ARCHITECTURAL DESIGN STATEMENT ADDENDUM

Prepared in response to DPHI request for further information dated 16 February 2026.

16-24 LORD STREET & ROSEVILLE 21-27 ROSEVILLE AVENUE

MARCH 2026

LORD STREET ELEVATION - RTS SCHEME

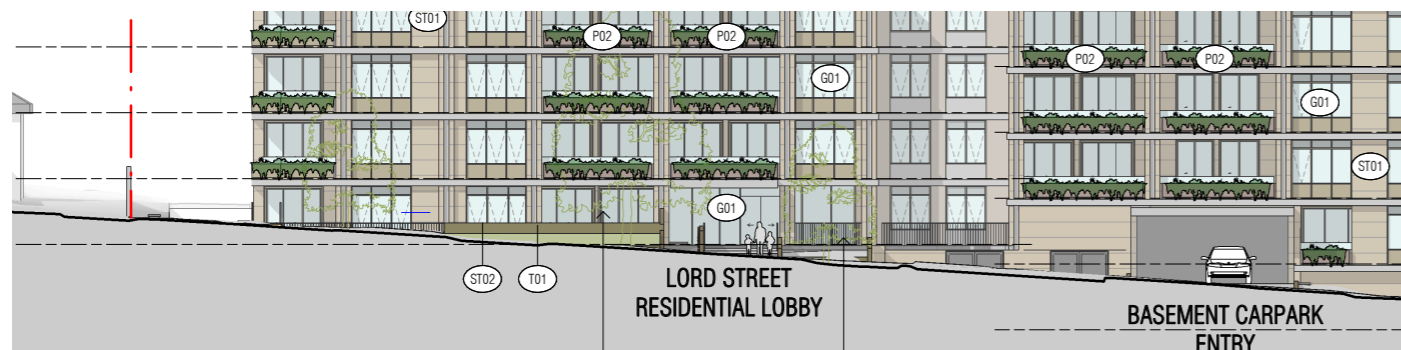
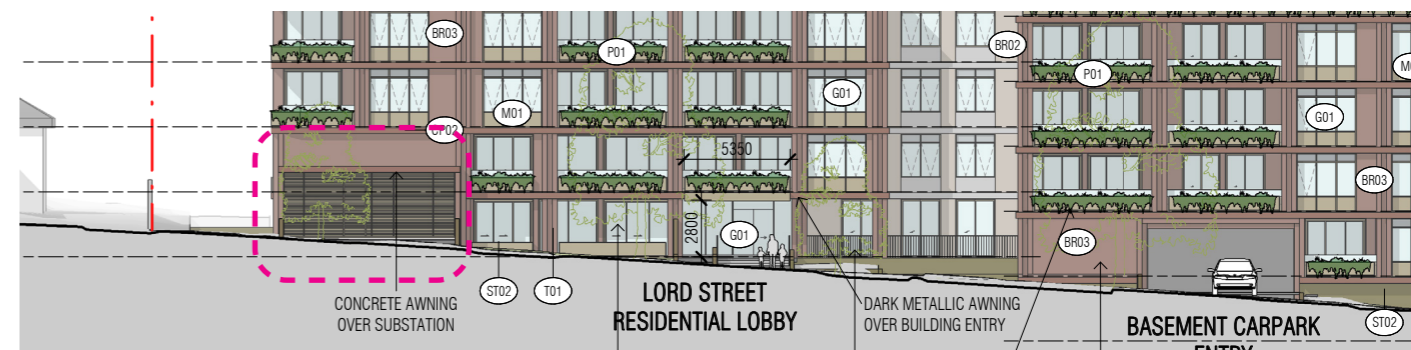
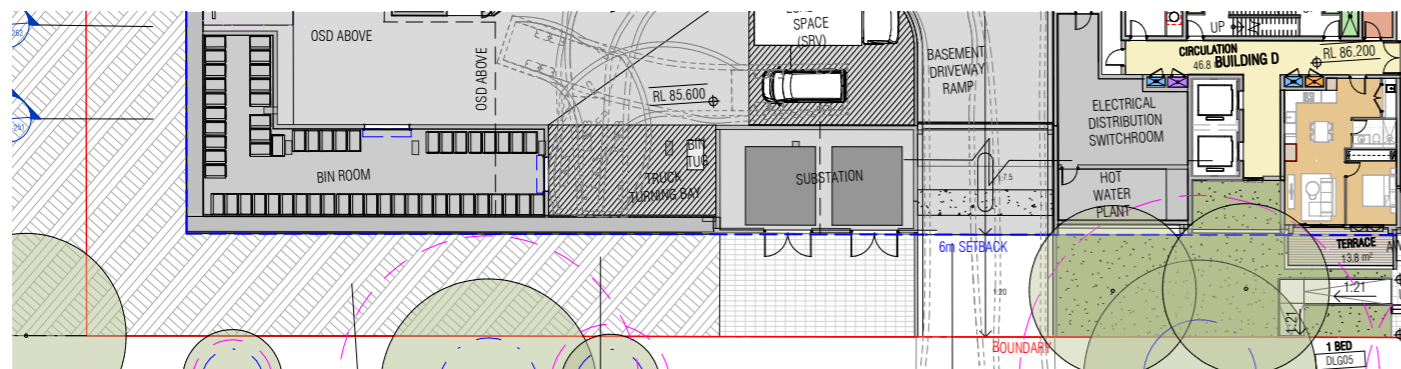
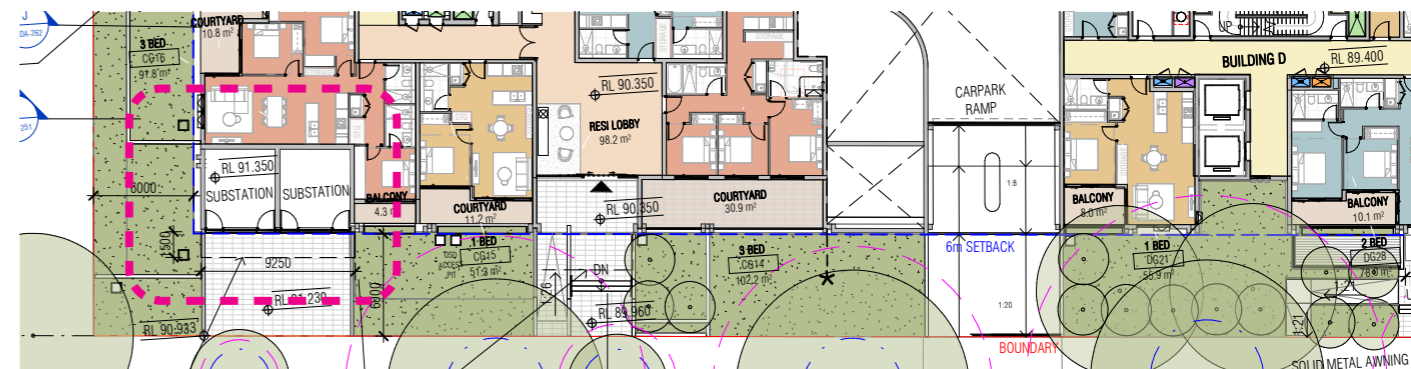
1.3 Reduce the width and excavation depth of the hard stand fronting the substation on Lord Street. Access to the substation from Lord Street is restricted given the level change, retaining wall to the public domain and masonry wall to the vehicle access way. Consider landscaping the area and providing access to the substation from within the internal loading area.

The substation has been relocated to an above ground location at the south west corner of the building (Lord Street frontage). The approach eliminated the need for excavation and facilitates the retention of street tree T20, previously proposed for removal. The substation has been carefully integrated into the design of the building.

Minor adjustments to the stormwater and lanscape strategy for the project have been adopted to respond to the revised substation location.

Ausgrid servicing requirements and potential interference with residential vehicles prevent access to the substation from the internal loading area.

NORTH ELEVATION - ROSEVILLE AVENUE

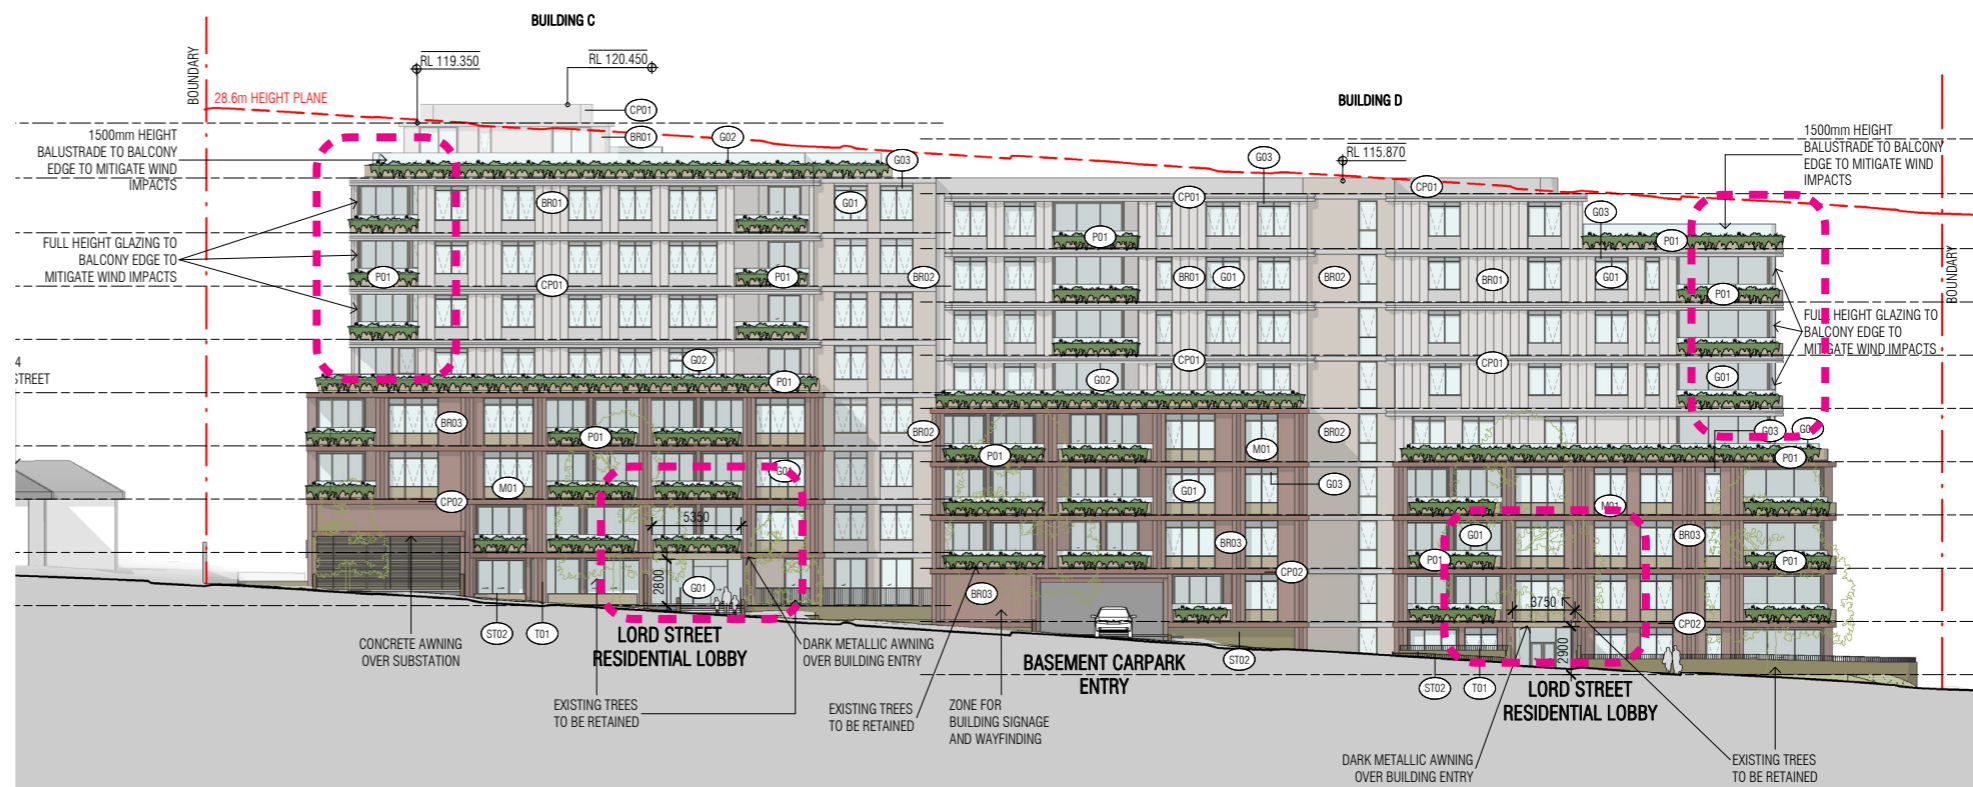
1.4 Provide details of height and design of all awning and utilities (including hydrant booster cabinets) facing Roseville Avenue and Lord Street.

1.5 Incorporate the recommendations of the wind study, as updated by the wind impact assessment addendum, into the architectural plans.

The height and design of awning and utilities, wind mitigation measures and specified in the Wind Impact Assessment Addendum Report, have been added to the architectural plans.

FIGURE 1.8

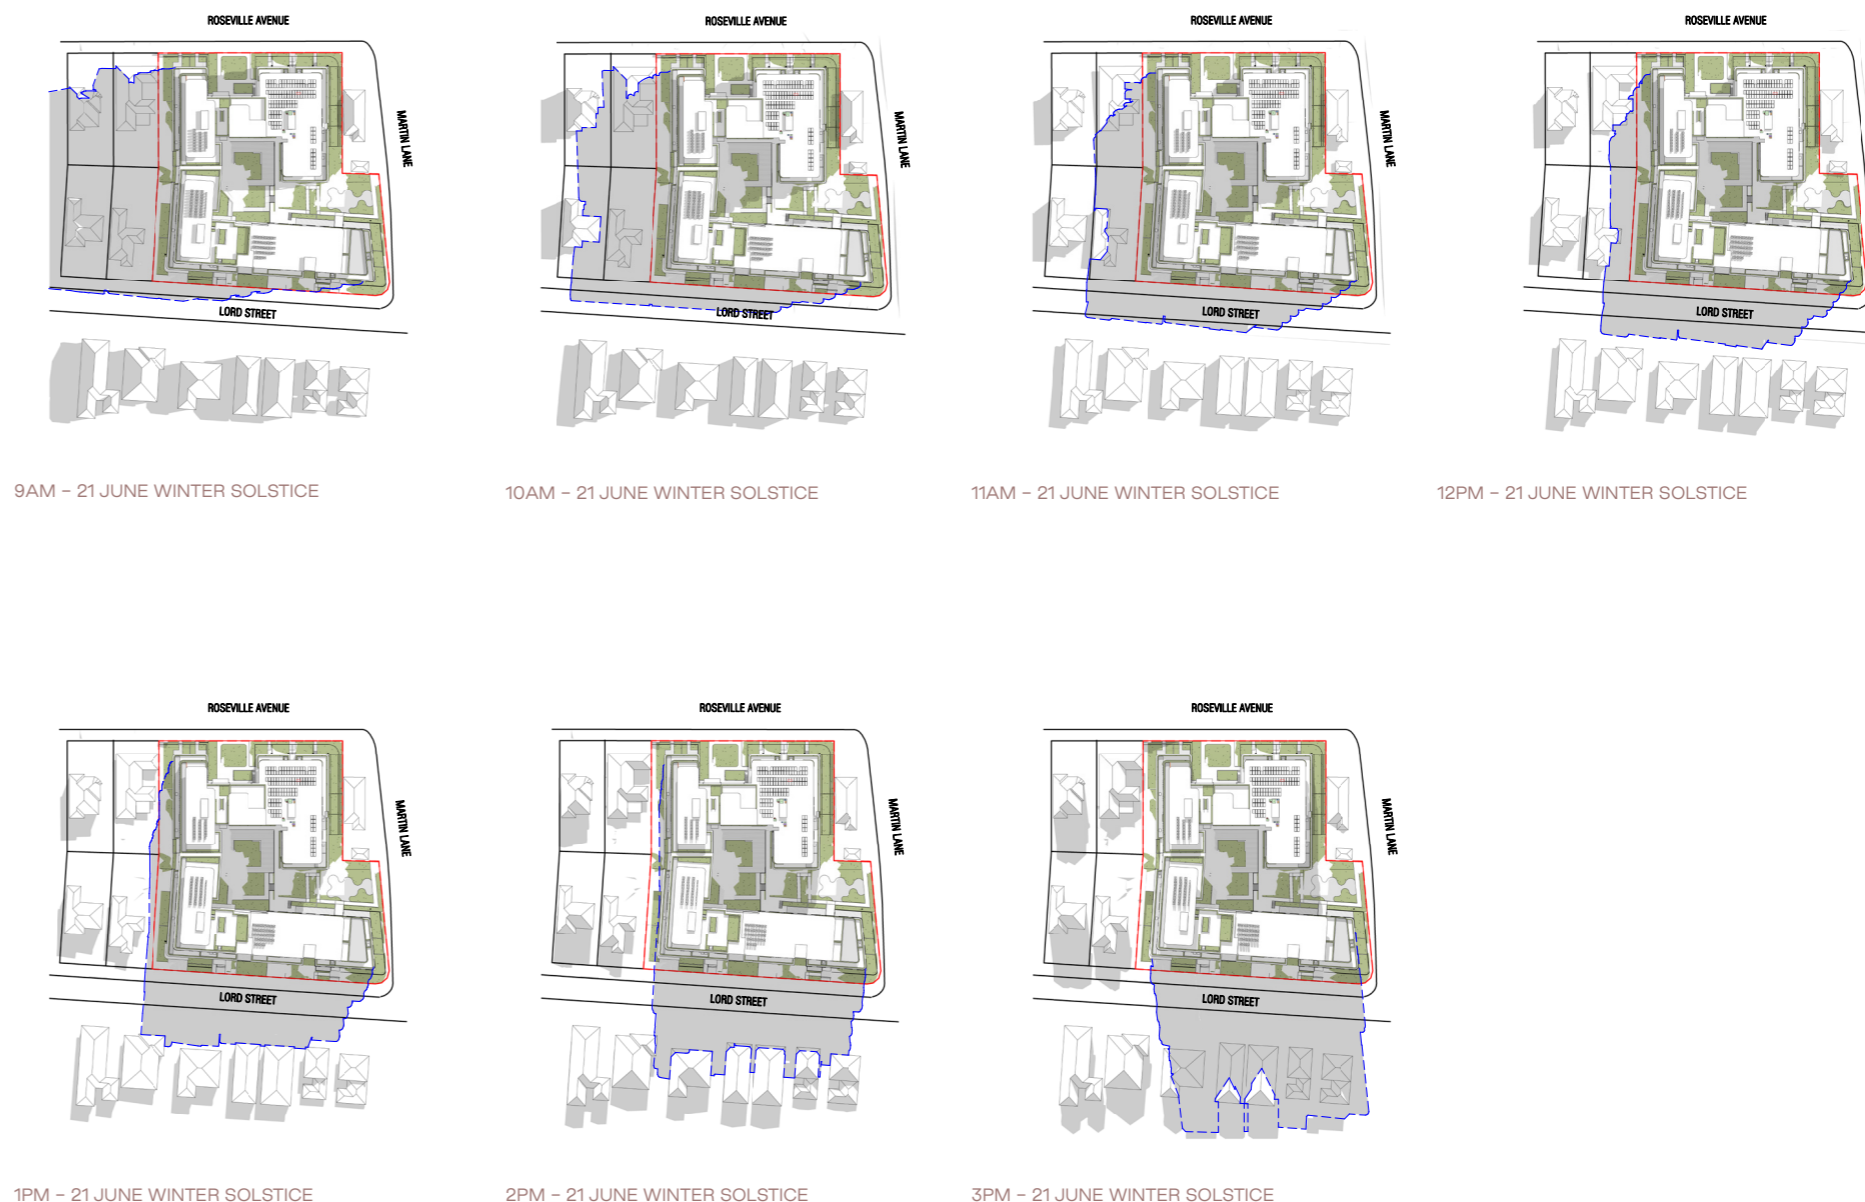
1.8 The Design Report Addendum (p25) does not properly identify the desired future character within the LMR exclusion zone, specifically the neighbours along the western boundary. The map proposes the western neighbours will redevelop into RFBs despite the current development controls limiting this. Provide updated shadow diagrams.

An analysis of the impact of the proposed development in relation to Council's final adopted controls has been undertaken. The controls would retain a 9.5m height control for the lots immediately to the west of the site, in the form of single dwelling houses.

The proposed development would inevitably create shading to neighbouring buildings to the west and south. The shadow diagrams illustrate that the shadows would be localised, primarily impacting the immediately adjacent buildings to the west. Shadows would extend over the building to the west through the morning mid-winter period but by midday the shadows would be limited to the setback zone. Similarly, shadow impacts to the south are limited to those properties directly opposite on Lord Street. These properties are not overshadowed during the morning period. The buildings are partially shaded from 1pm. Given the orientation of the buildings, additionally shadow impacts relate to the front of the buildings only, noting that the rear gardens are shaded by the buildings themselves during the afternoon period.

No additional overshadowing arises from the inclusion of the discrete roof top elements that project above the maximum permissible height plane. These elements are setback within the development.

The design of the building ensures a minimum of 3 hours of solar access to neighbouring dwellings to the west and south is retained.

FIGURE 2.1

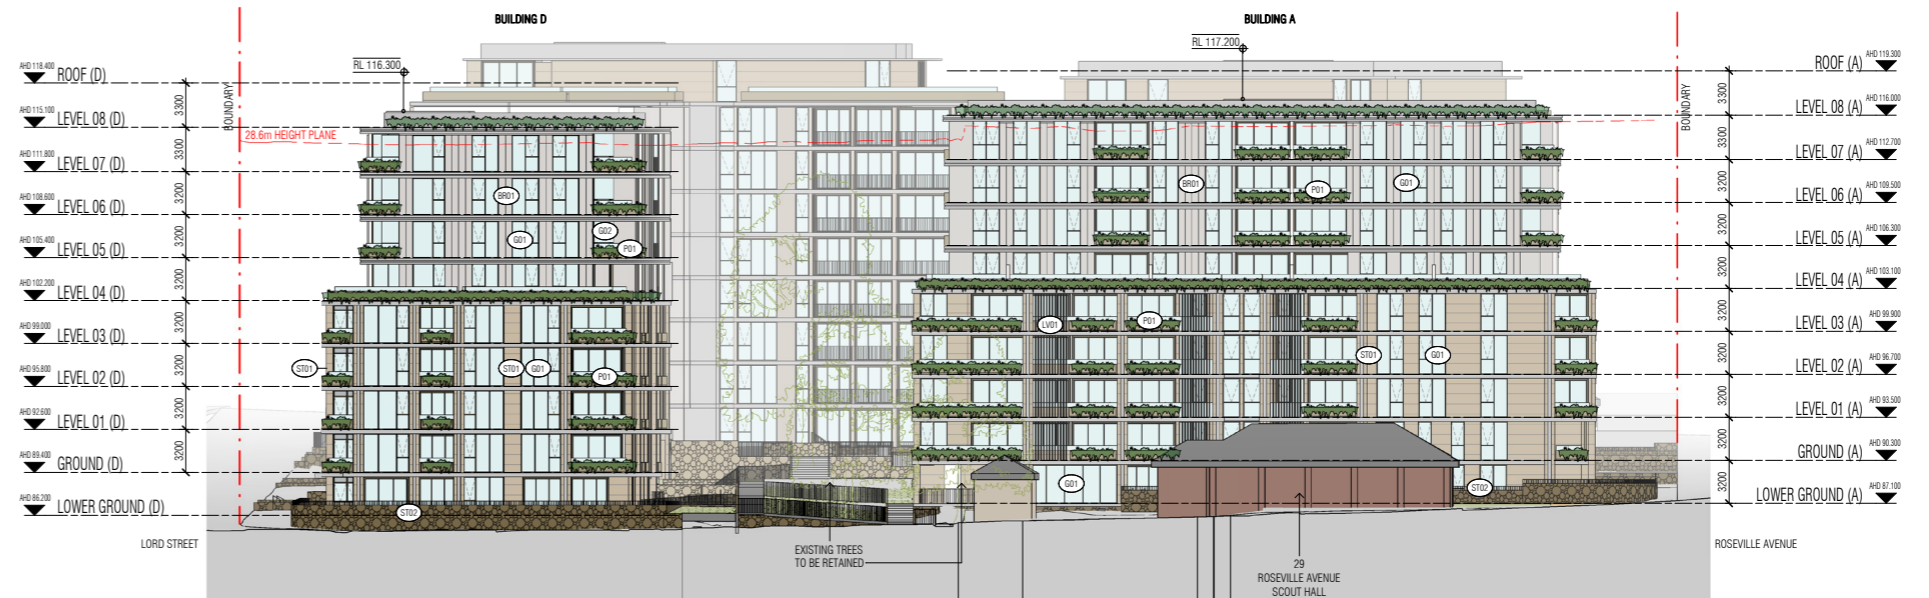
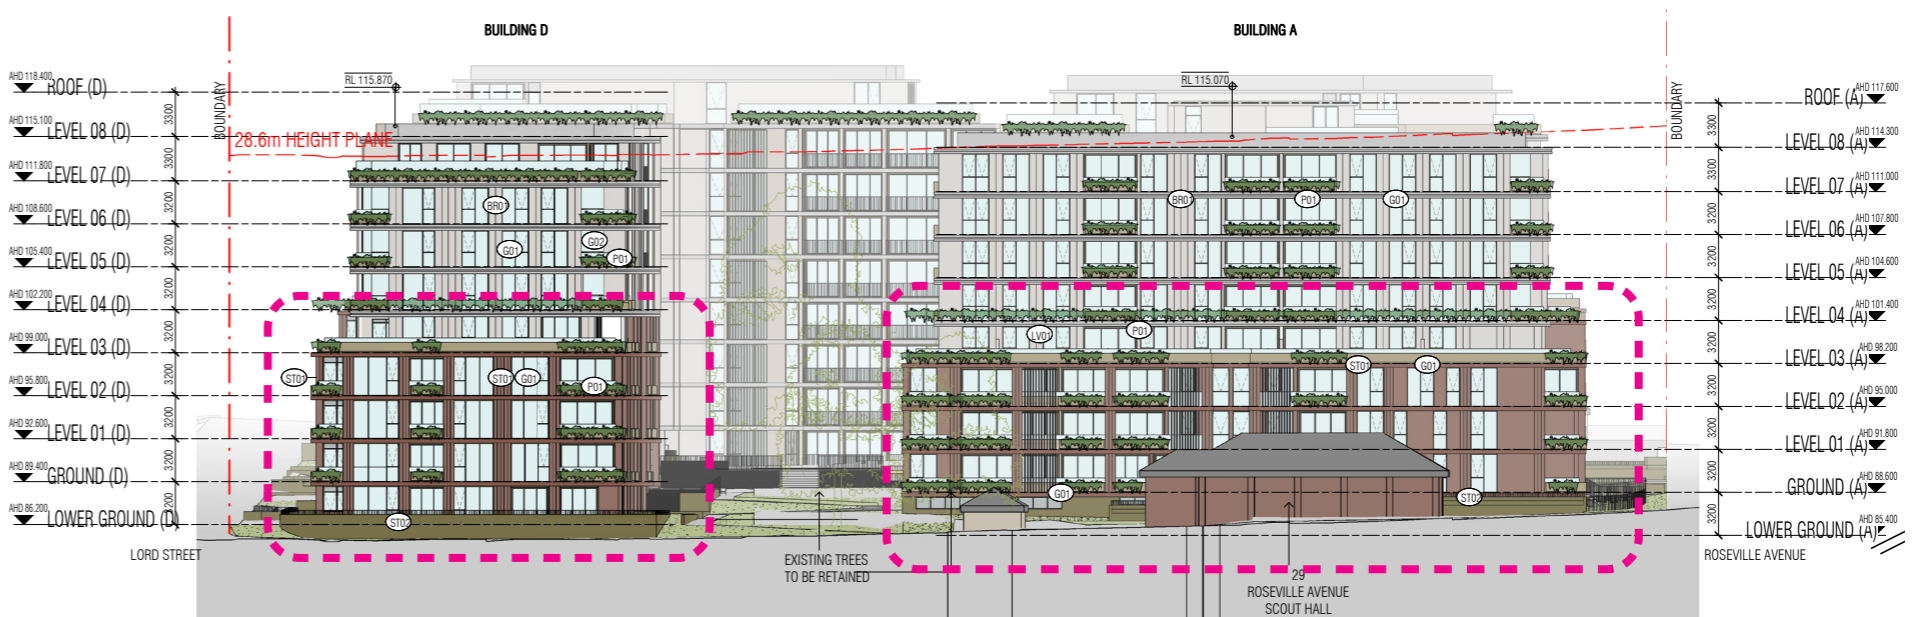
2.1 Reducing podium heights at the elevation adjoining the heritage, Scout Hall. 3 storey podium is recommended.

2.2 Increasing upper level setbacks (front/side) to 10m minimum (12m is required per Council's DCP for sites adjoining heritage items).

The podium heights of Buildings A and D have been further reduced. Building A, immediately adjacent to the Scout Hall, adopts a reduced podium height of 3 storeys. The street setbacks are proposed in accordance with the ADG, which requires street setbacks to respond to the prevailing streetscape pattern and desired future character. In accordance with ADG section 2G, the proposed street setbacks are consistent with the prevailing setback pattern in this context, where the development pattern to the west will be retained and will transition to higher densities to the east.

Given the courtyard design of the proposed development, the setback requirements proposed by Council cannot be achieved.

FIGURE 2.3

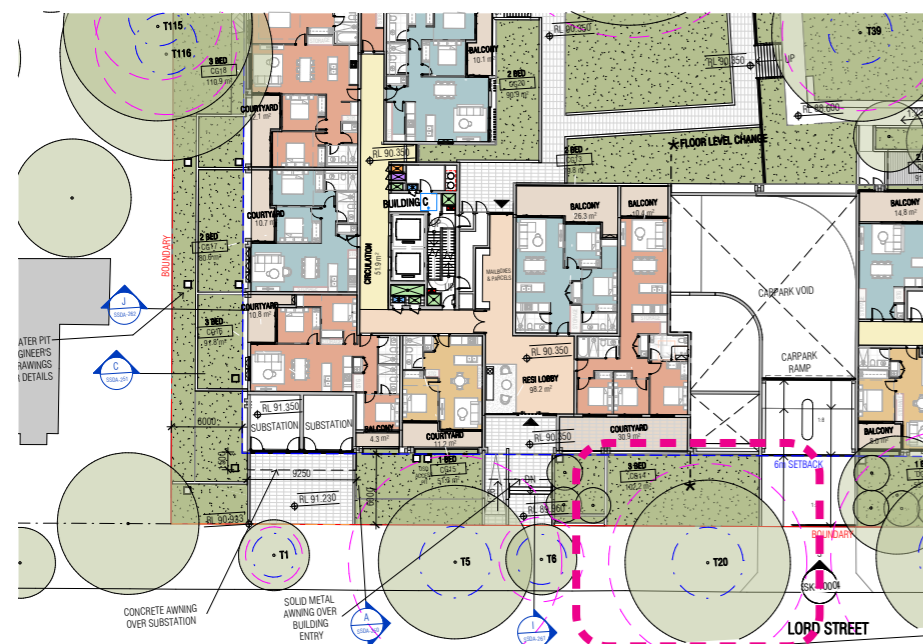
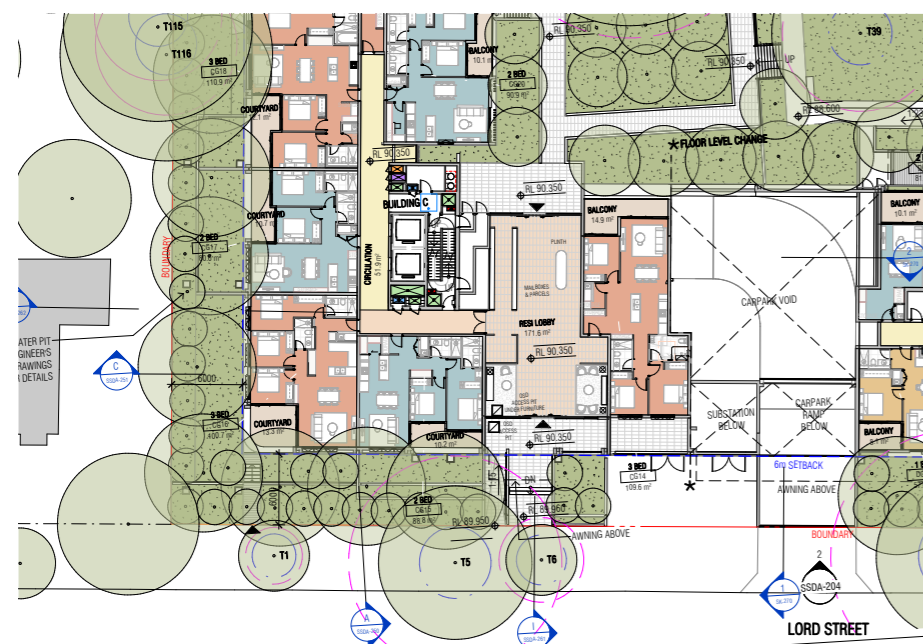
2.3 Council does not support the removal of T20 and has indicated that consent for the removal of this tree will not be granted.

The proposed substation has been relocated to the south western corner of the development to reduce impacts to tree T20 and eliminate the need for the removal of this tree. T20 is proposed for retention.
